Permanente Creek Flood Protection Project

Fifth Addendum to the Final Subsequent Environmental Impact Report State Clearinghouse No. 2007052074

February 2020

Figure 1: New Pedestrian Pathway at McKelvey Park.

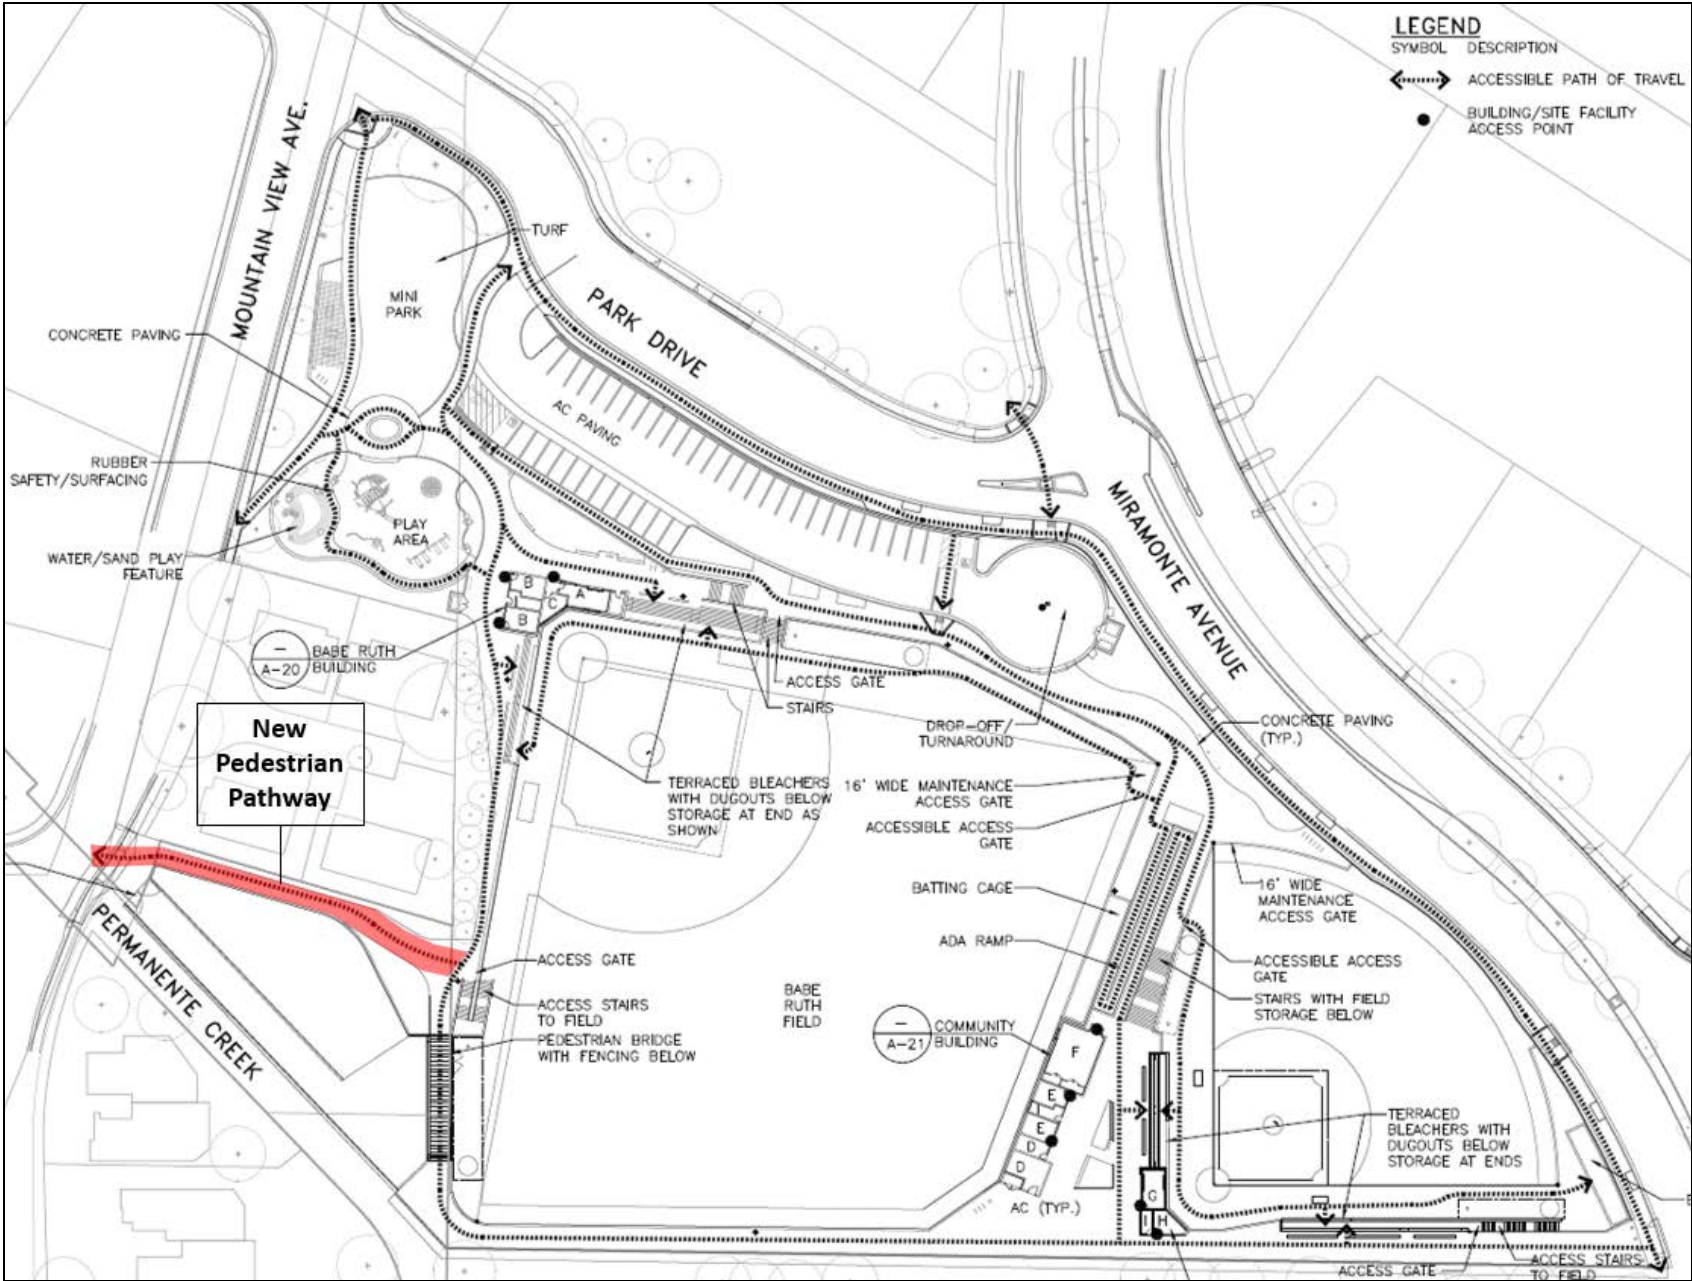
Valley Water proposes minor modification to the project design at the McKelvey Park Detention Facility in Mountain View to construct an additional approximately 200 feet of pedestrian/bicycle pathway (Figure 1). The pathway would be located on the western side of the project area near the floodwall on Permanente Creek and adjacent to residential properties (923 Mountain View Avenue and 1295 Abraham Court). The parcel on which the pathway would be located (assessor's parcel number 18903041) was acquired by Valley Water subsequent to the 2012 EIR and is described in the first Addendum to the EIR, which allowed for extension of the detention basin adjacent to Permanente Creek.

The approximately 200-foot long pedestrian/bicycle pathway would be approximately 7 feet wide and would run in the east-west direction extending from Mountain View Avenue (west end) to its intersection with a previously proposed pathway running in the north-south direction along the west side of Babe Ruth Field (east end). The previously proposed pathway connects to other parts of McKelvey Park including the Little League Field to the east and the play area, mini-park, and parking lot to the north.

There would be a 6-foot tall black vinyl coated chain-link fence along the south side of the pedestrian/bicycle pathway adjacent to the detention basin. Bollards (short sturdy posts) with downward-facing lights would be installed along the south side of the path to light the path during early morning and evening hours. The light bollards are designed to prevent light spillover to adjacent properties.
